Memorandum

~~AGRICULTURAL IMPACT OF CHEVRON DALY UNIT #3 REDUCED
ACREAGE SITES~~

RE: Reduced Spacing Locations - Daly Unit No. 3
5A-12-10-28 (WPM)
5D-12-10-28 (WPM)
6A-12-10-28 (WPM)
6D-12-10-28 (WPM)

Subject : DALY INFILL LOCATIONS
Section 12-10-28 (WPM)

Chevron 15D-27-9-28

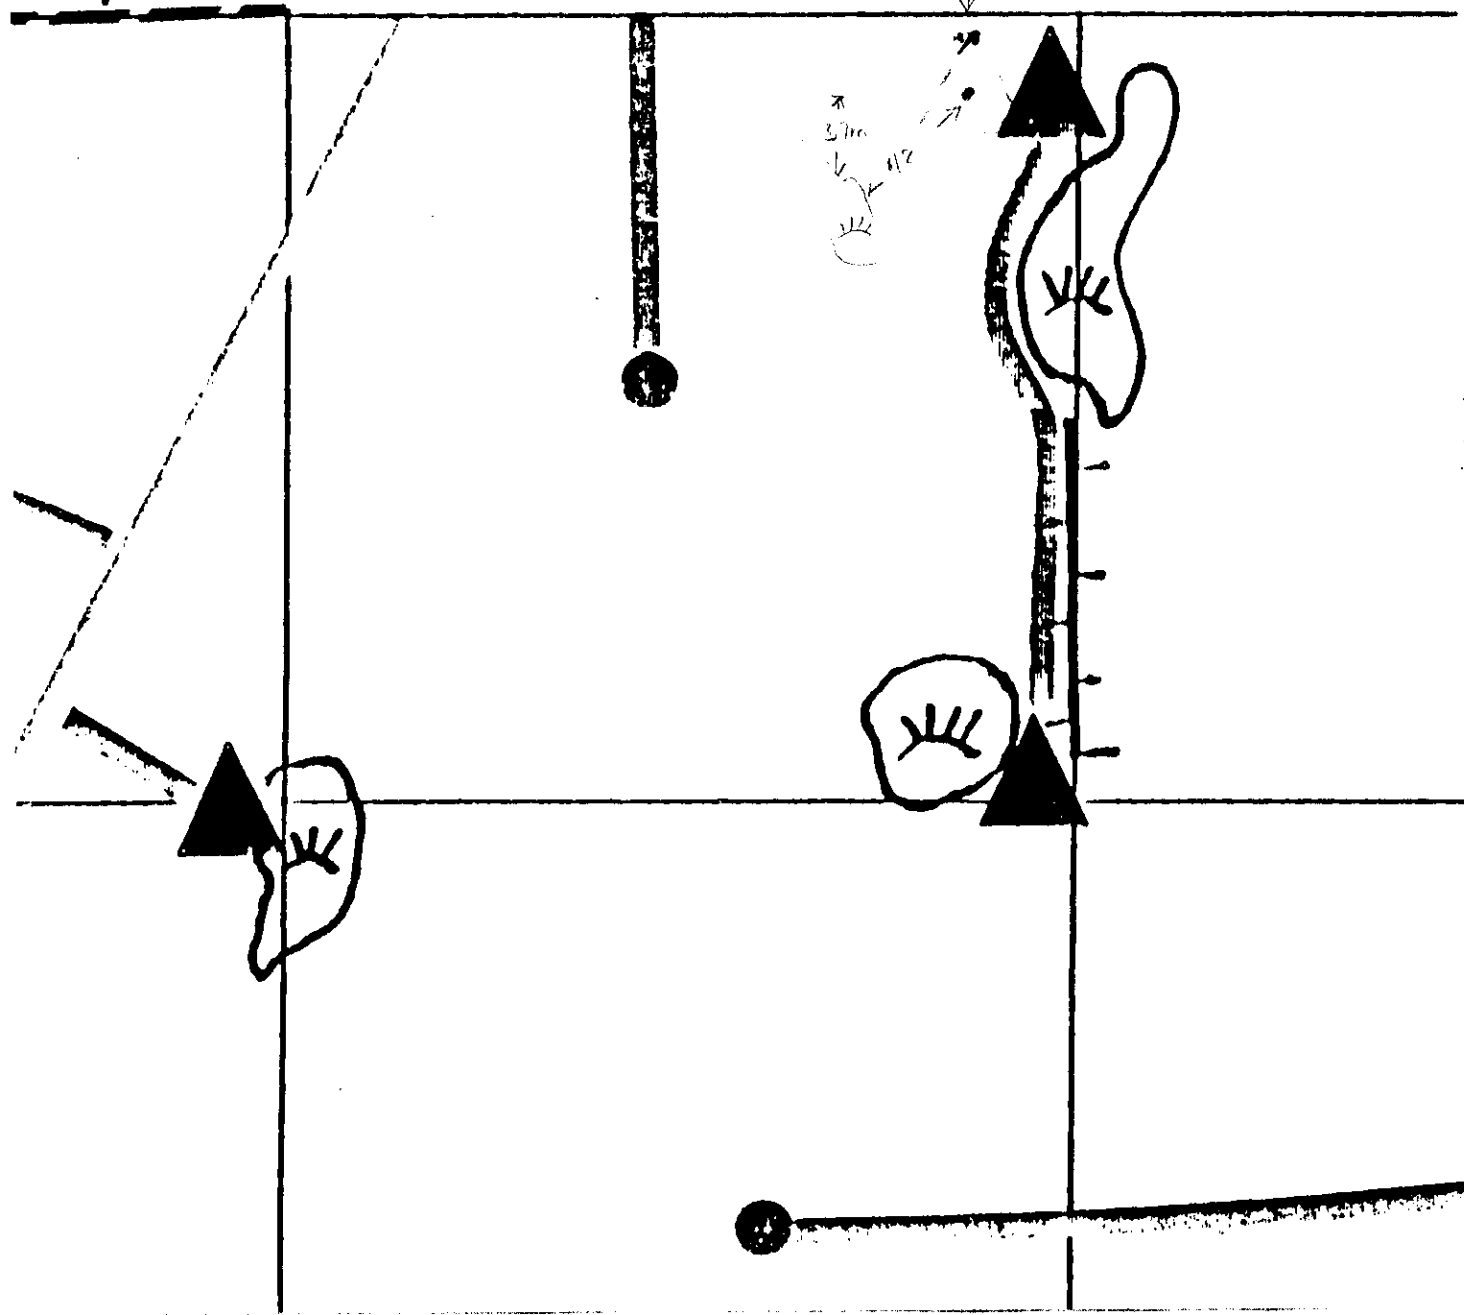
On April 26/88 Ian McGregor and I inspected the 15D site to determine what disruption it would cause to agricultural activities. Upon arrival at the site we determined that the location was not as proposed in the "Berrien Report". The well had been offset to the west and appeared to be the high spot between two sloughs. We felt that if the well was moved closer to the east slough that there would be less impact upon the arable land. Future road development to 15A (if drilled) could skirt the slough and not affect as much land.

On April 27/88 I met with the landowner Mr. Walter Kool. Mr. Kool stated that he preferred the wellsite to remain in it's surveyed location. He felt that this would allow him the most efficient use of his equipment and land. He stated that if the 15A site was ever drilled he probably wouldn't want the road to be from the 15D site so that the proposed road location for the 15D well was not an issue.

I do not think that this wellsite is in its best possible location but will concur with the wishes of the landowner.

FIG NO.1

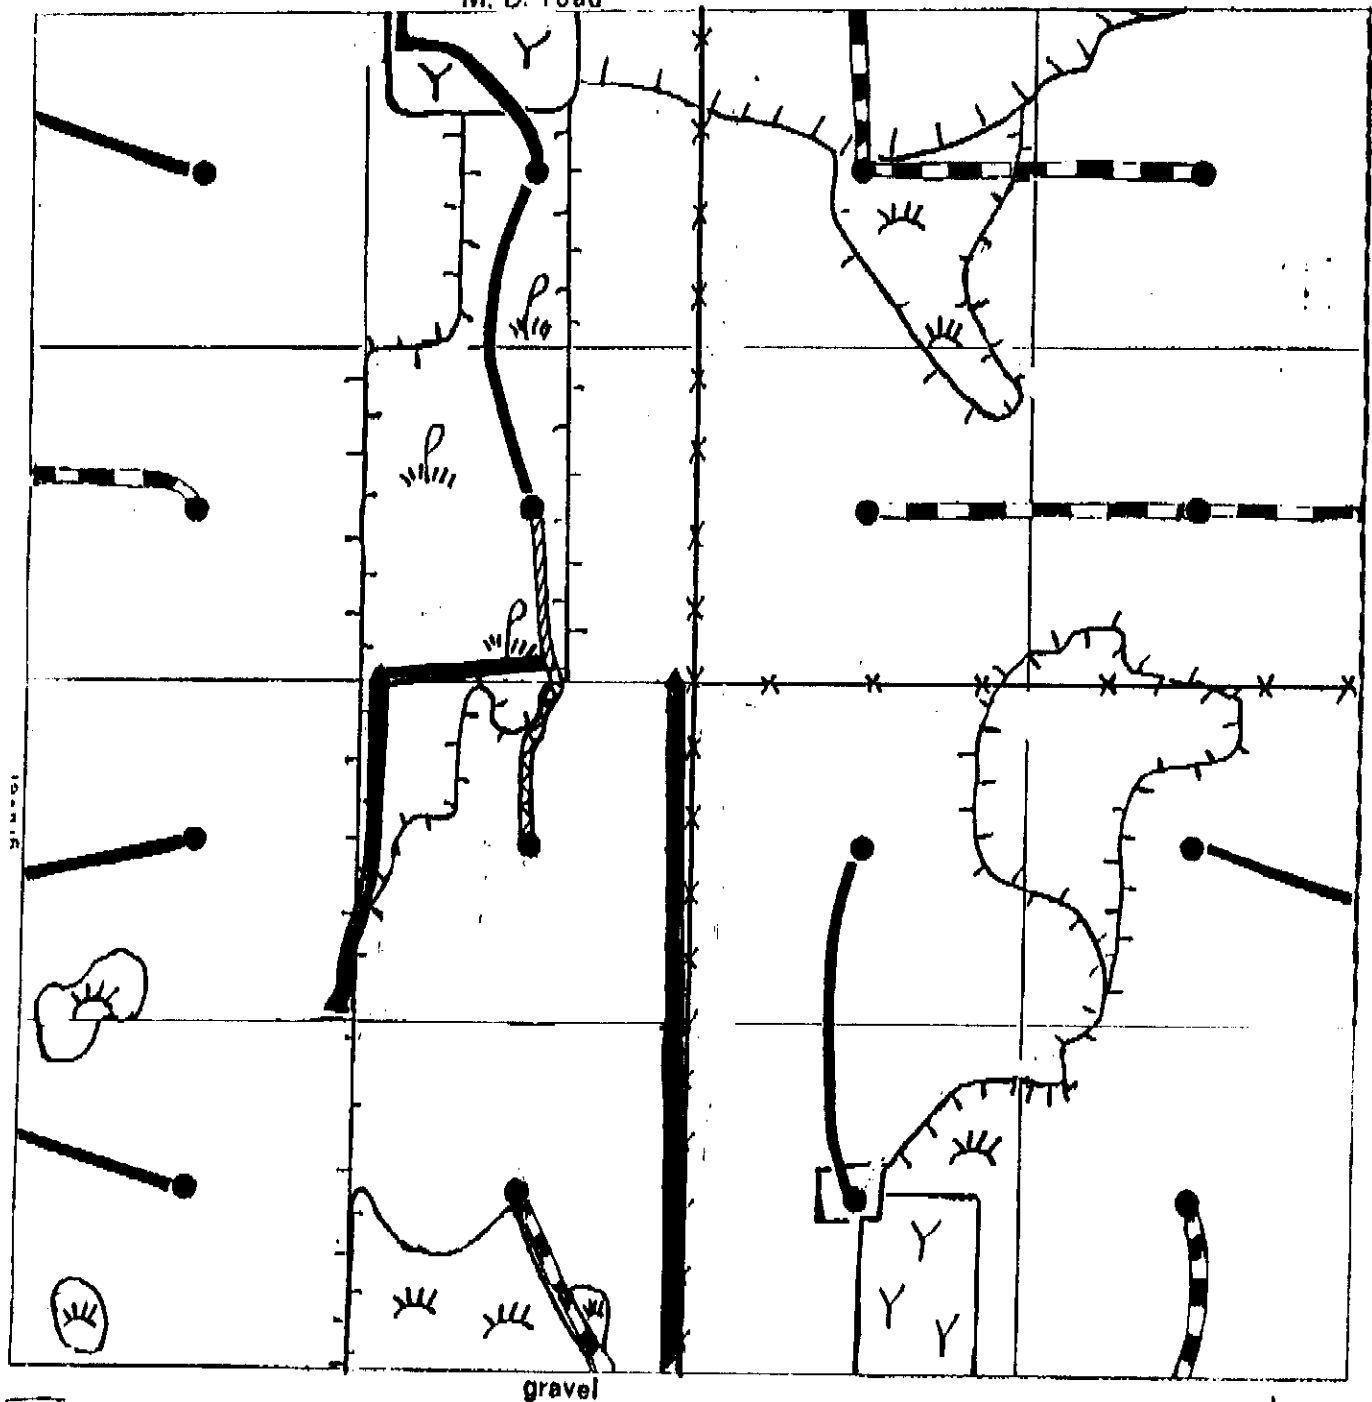
However, in keeping with the intent of the Board's decision and as a result of inspection of the proposed well sites and access roads, we suggest that the impact of the additional well sites could be reduced significantly by the following modifications:

1. Location 5D-12-10-28 (WPM)
Relocation of this well site to a point 40 m east of the centre of the spacing unit (as opposed to 40 m west) would remove the well from cropped land and into pasture land.
2. Location 5A-12-10-28 (WPM)
Relocation of the wellsite 50 m north would shorten the access road and move the well from the centre of a small ravine where environmental damage would be more severe in the event of an oil or salt water spill.

- a) Removal of the built-up road between the 3-12 and 6-12 wells.
- b) Access to the 5A-12 and 5D-12 wells via a new trail from the existing trail between the 6-12 and 11-12 wells, west along the north boundary of Lsd. 6 and south along the west boundary of Lsd. 6.
- c) Access to the 6A-12 and 6D-12 wells via a trail from the south along the east boundary of Lsds. 3 and 6.
- d) Access to the 6-12 wellsite via the existing trail between the 11-12 and 6-12 wells.

The above suggested modifications to access roads are illustrated on Fig. No. 1.

Prior to submitting applications for well licences, you are requested to discuss these suggested modifications with the landowner. Your application for well licences should include a report on such discussions.

Chevron Proposal

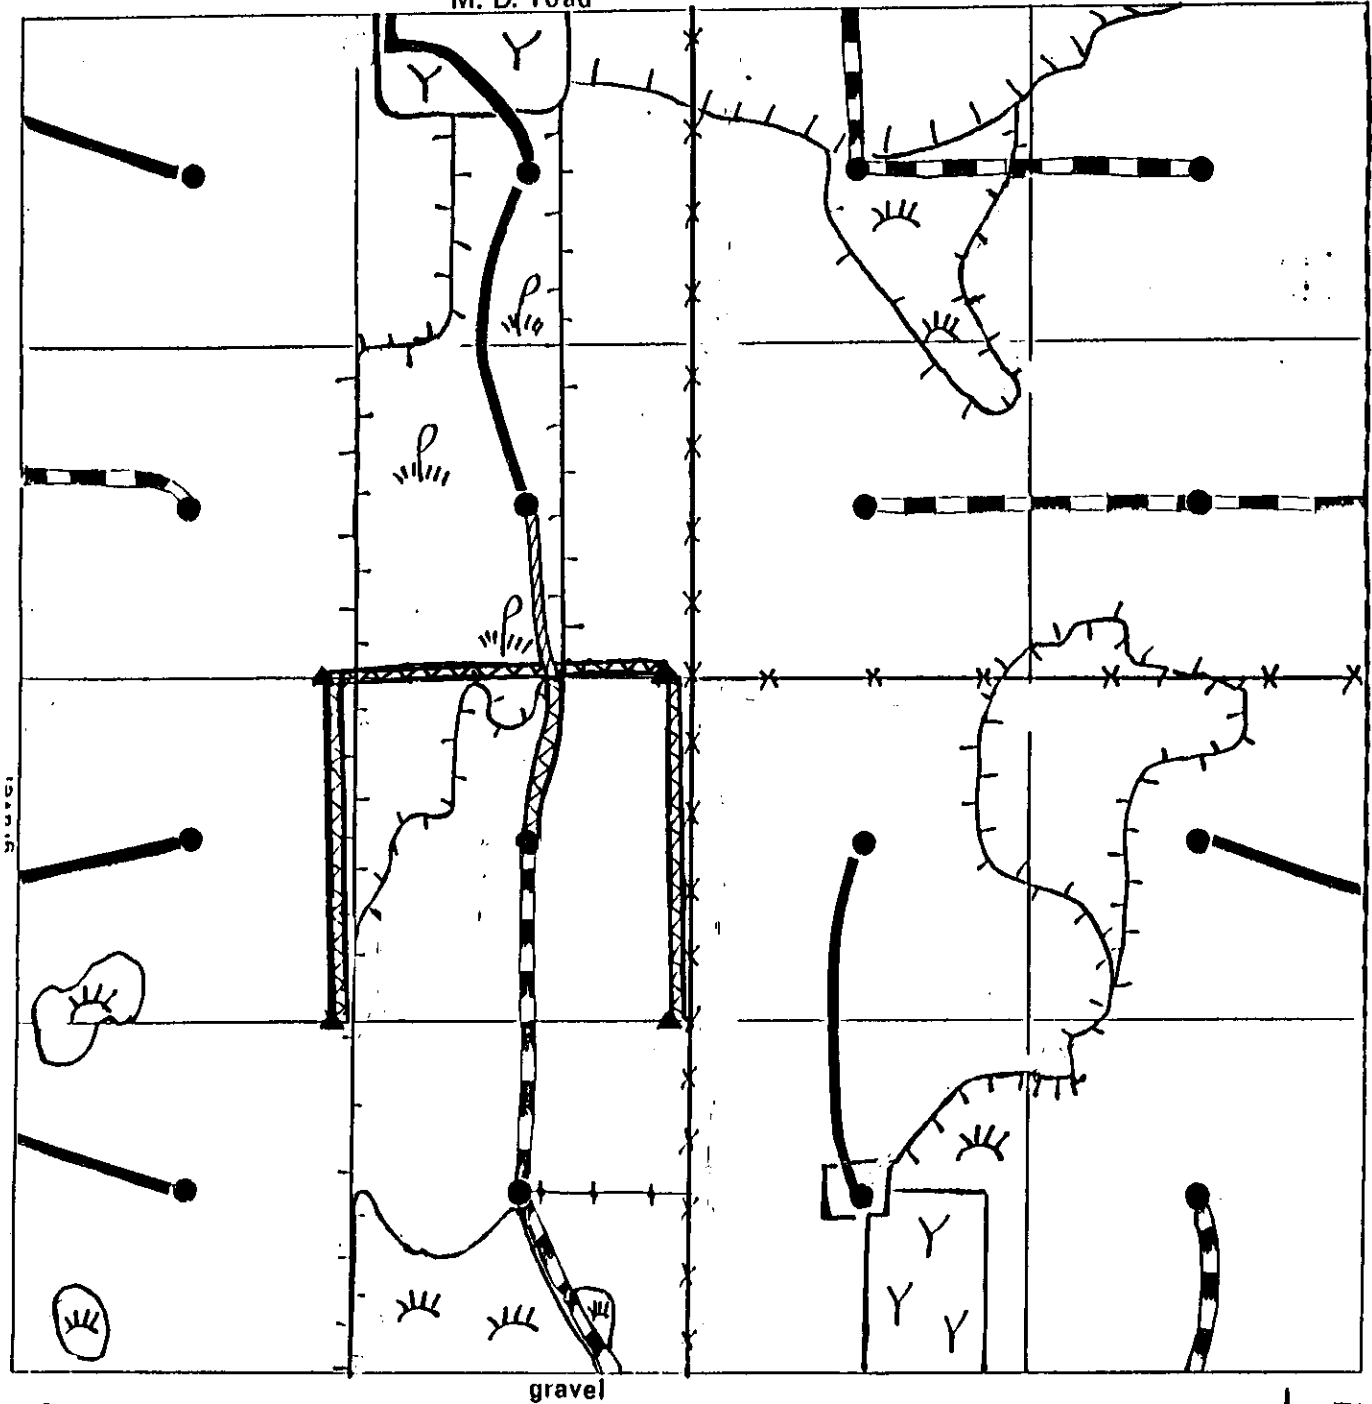
- Above ground hydro lines into 6-12 to 3-12 should be buried.
- General:
- Chevron's proposal for the well locations are acceptable excluding 5D.
 - Chevron's proposed access to these wells is unacceptable from an agricultural point of view.

Our Proposal
M. D. road

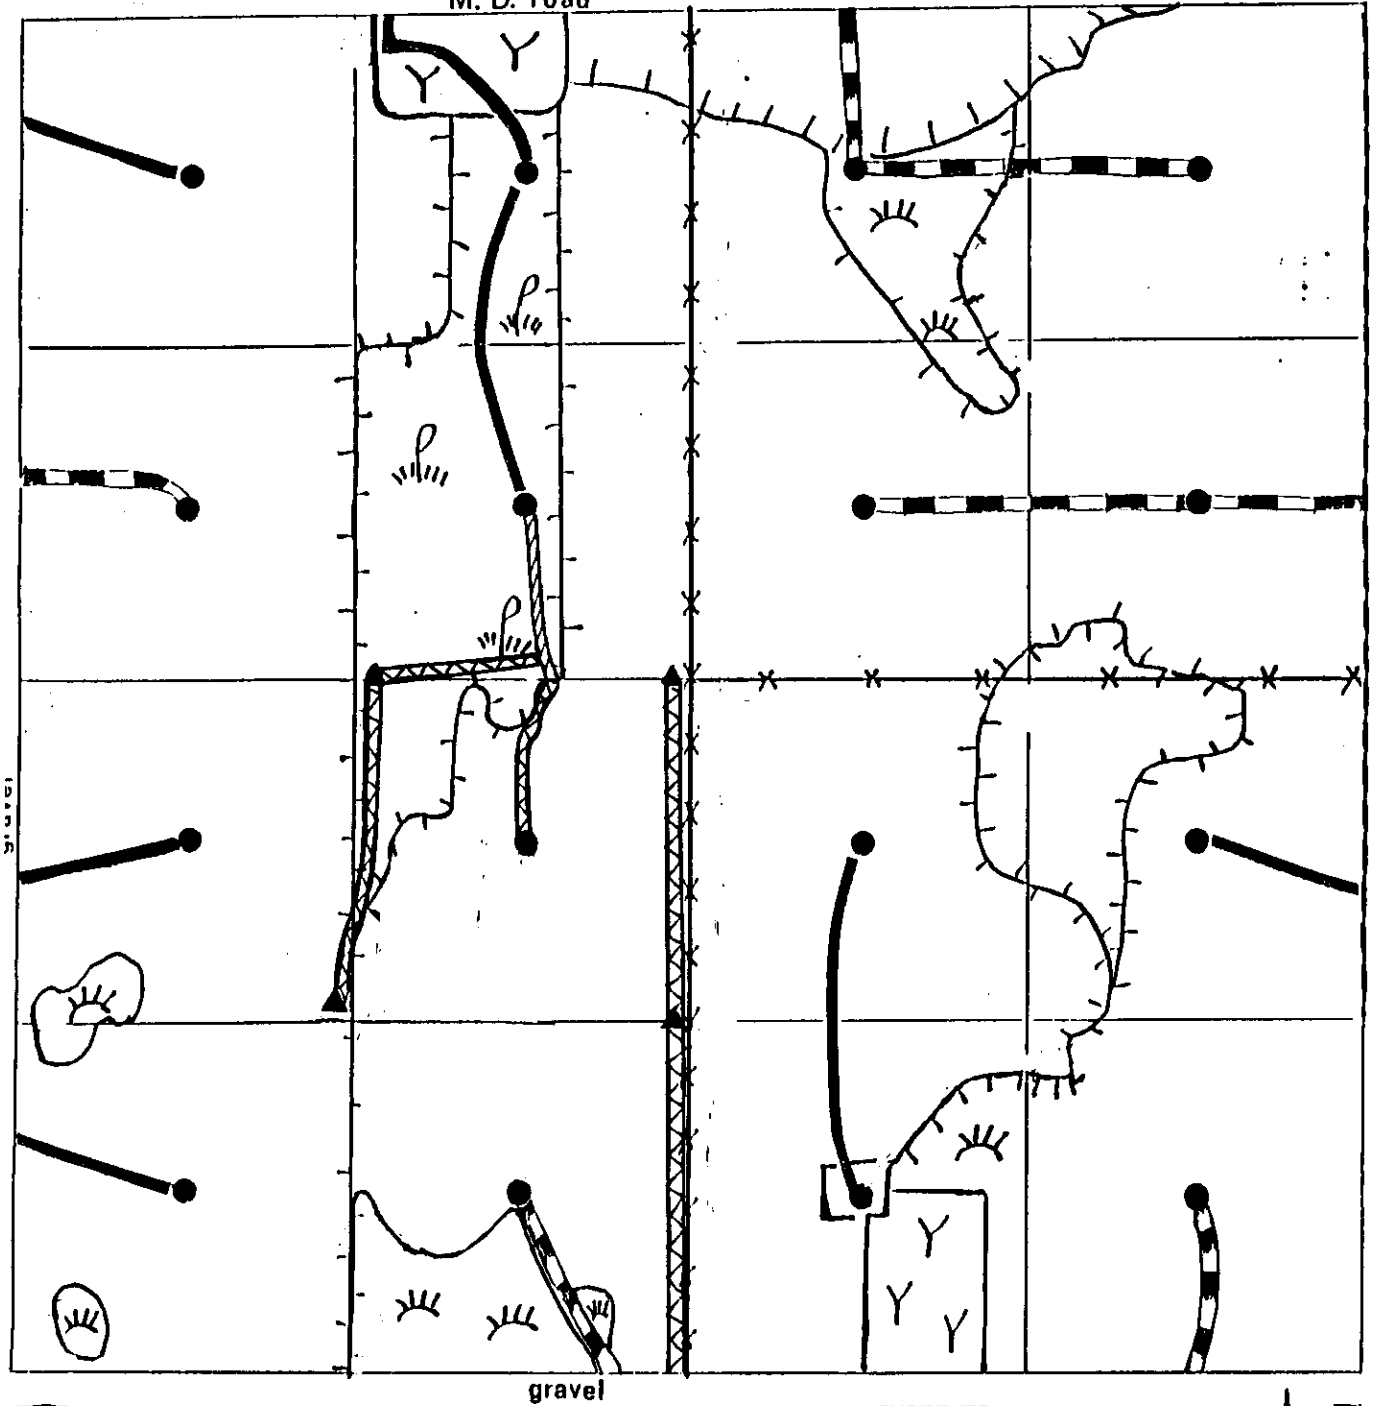
- 5D-12-10-28: We recommend offsetting this well 40m east of the spacing centre as opposed to Chevron's proposal of offsetting it 40m west. This would place the well on pasture land instead of crop land. Access to this well would be as proposed by Chevron.

- 5A-12-10-28: We recommend this well be offset \sim 50m north of the spacing centre in order to shorten the access road and raise the well head out of the centre of a natural runway. As there is cultivated land on all sides the location of this well is not a high priority. Access to this well should be from inside the pasture land for as much as possible.

- 6D-12-10-28: Chevron's proposed location of this well is acceptable. Access to this well should be from the south following the hydro lines and 1/2 mile fence line.

- 6A-12-10-28: As per 6D-12-10-28.
- Other:
- Existing road from 3-12 to 6-12 should be removed. Access to 6-12 should be via 11-12. This would require leasing of an existing trail from 11-12 to a gate at the cultivated field north of 6-12, and leasing of crop land south to six.
